RECORD NO.: PLAT-25-000029 (S245-193) **SENIOR PLANNER:** Sharmila Shrestha**LOCATION:** McNeil Street, north of Scyene Road**DATE FILED:** June 13, 2025**ZONING:** R-7.5(A)**CITY COUNCIL DISTRICT:** 5**SIZE OF REQUEST:** 0.4086-acres**APPLICANT/OWNER:** Metro Builders, LLC

REQUEST: An application to create one 0.2024-acre (8,817-square foot) lot and one 0.2062-acre (8,980-square foot) lot from a 0.4086-acre tract of land in City Block A/5830 on property located on McNeil Street, north of Scyene Road.

PLAT-25-000029 (S245-193)

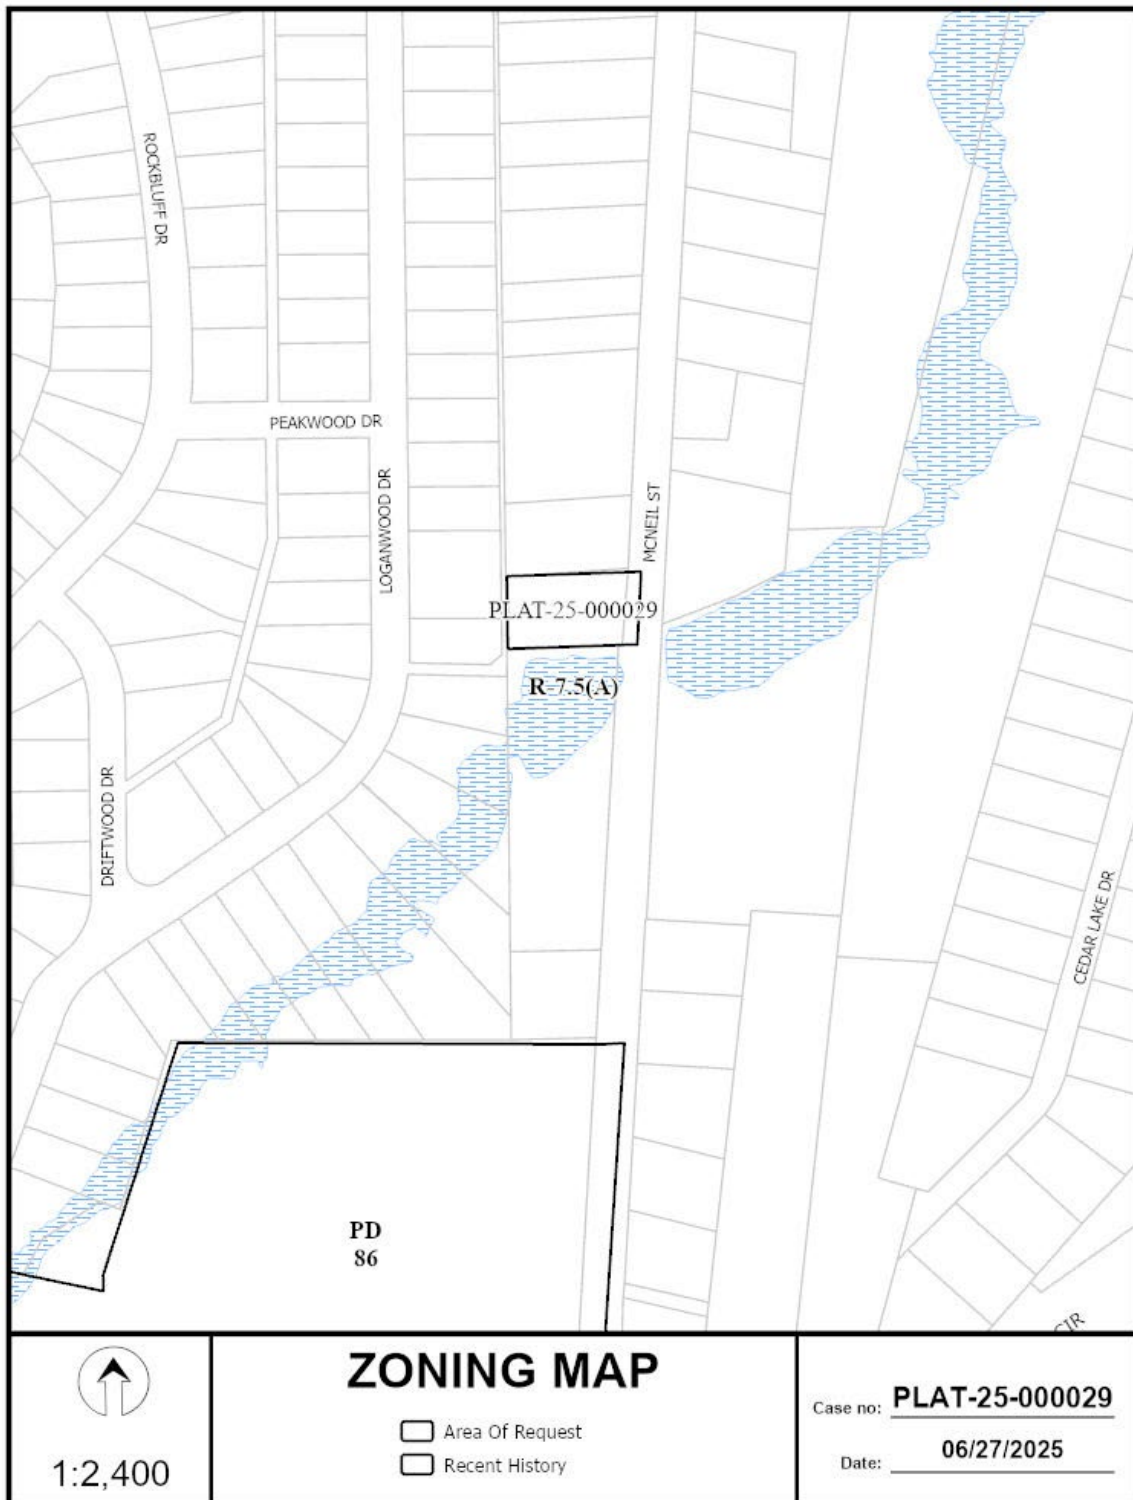
14. On the final plat, dedicate 25 feet of right-of-way (via fee simple or street easement) from the established centerline of McNeil Street. *Sections 51A-8.602(c), 51A-8.604(c) and 51A-8.611(c).*

16. On the final plat, show how all adjoining right-of-way was created.
17. On the final plat, show recording information on all existing easements within 150 feet of the property.
18. On the final plat, show Volume 72206, Page 723, Deed Records, Dallas County, Texas.
19. On the final plat, show Volume 5471, Page 319, Deed Records, Dallas County, Texas.
20. On the final plat, show Volume 4550, Page 241, Deed Records, Dallas County, Texas.

21. On the final plat, identify the property as Lots 1 and 2 in City Block F/5830.
